# PARISH OF ST. CHARLES

### MEMORANDUM

RE: **BCG Building Corporation**  
**Office and Warehouse**  
**10016 River Road**  
**St. Rose, 70087**

With a memorandum dated August 11, 1998, from your office, we have reviewed the drawings you sent us and have inspected the site on the above-referenced development. We have one objection to the plan with respect to drainage.

Plan of Resubdivision of Lot UM-1  
into Lots UM-1A and UM-1B made  
for Universal Match Company at the  
request of Mr. Charles Gudger.  
New Orleans, LA March 25, 1998

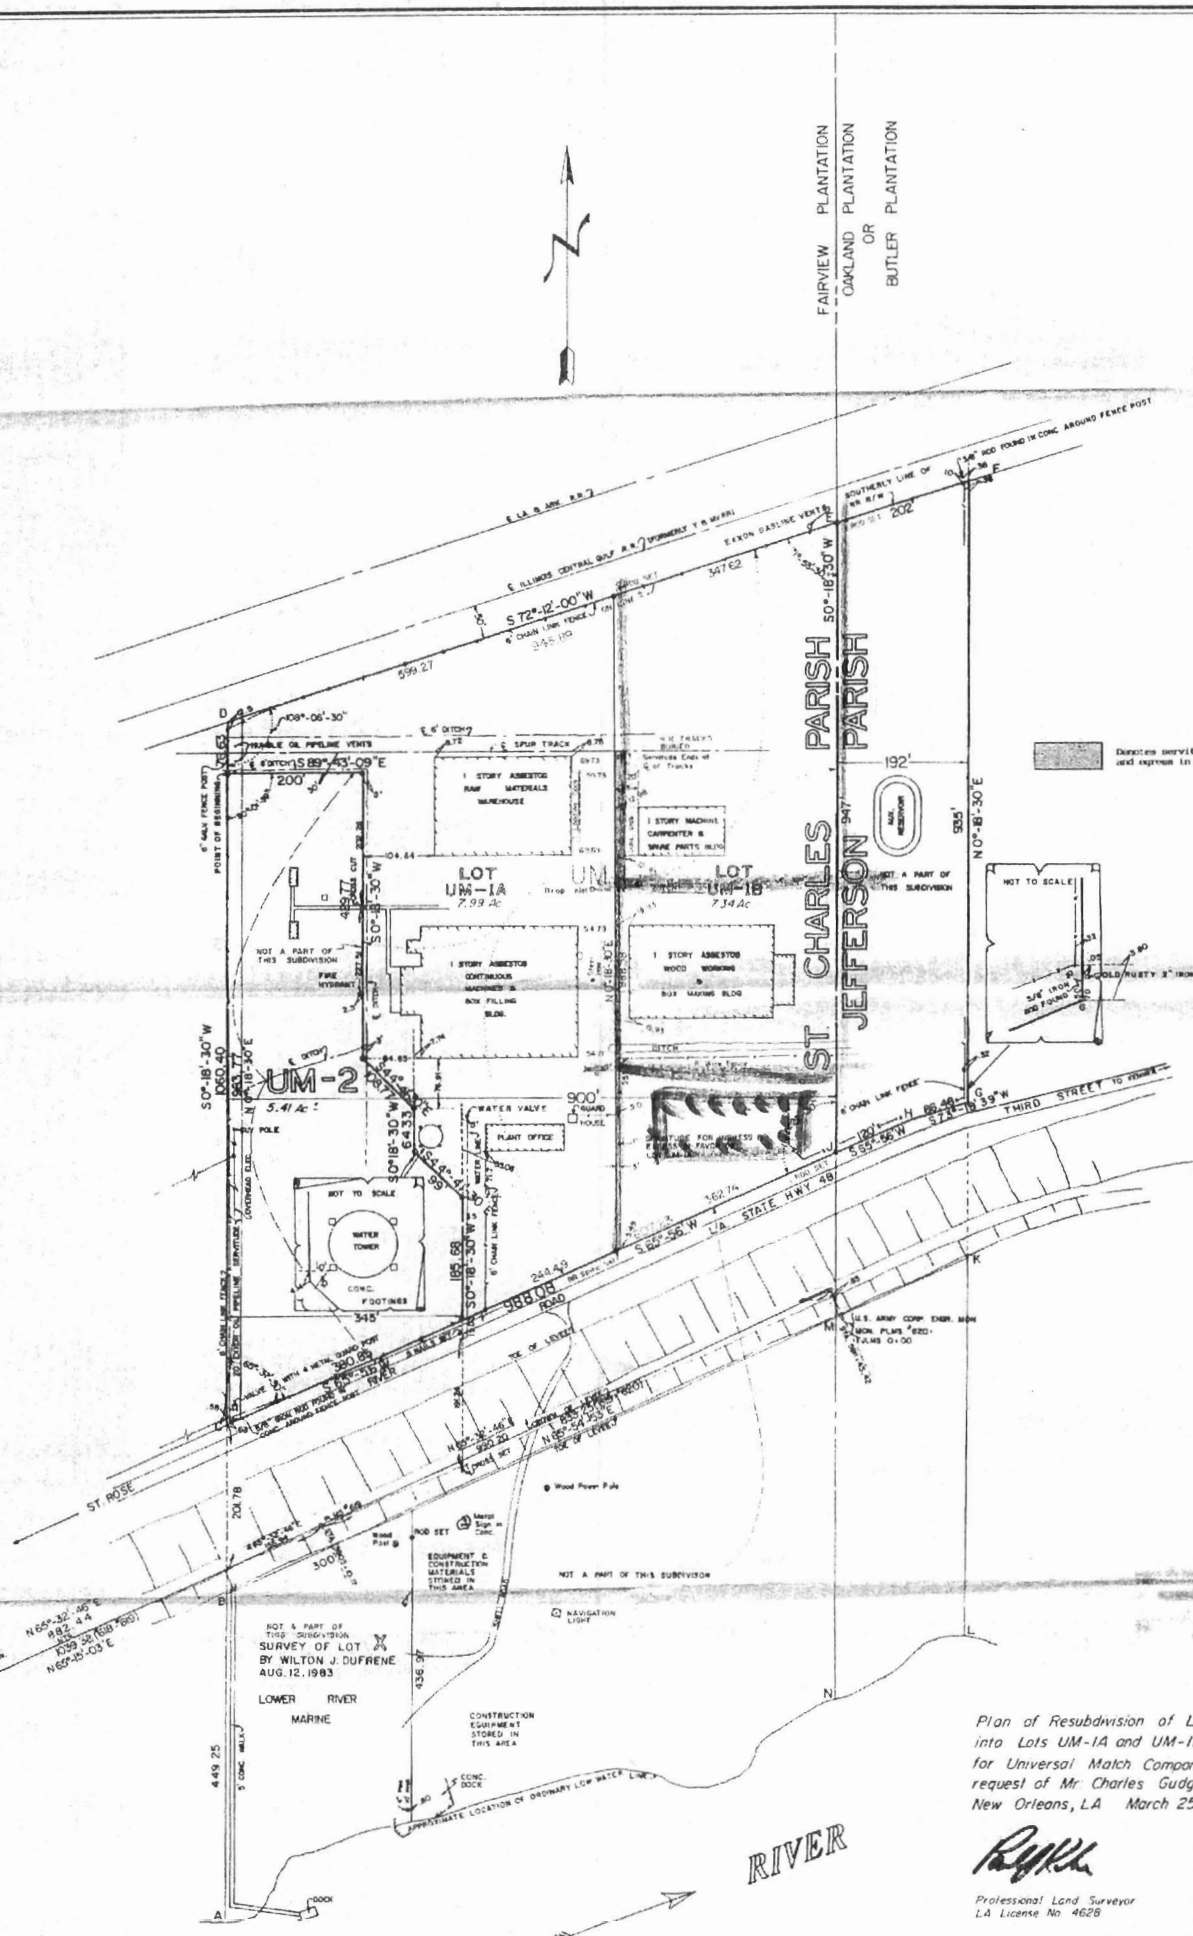
The survey of Lots UM-1B and UM-1A show two (2) culverts, near the common property line, servicing both east-west ditches of Lot UM-1B. Those culverts are not shown on any other plan. Those culverts shall not be removed or blocked as part of the drainage plan for this development.
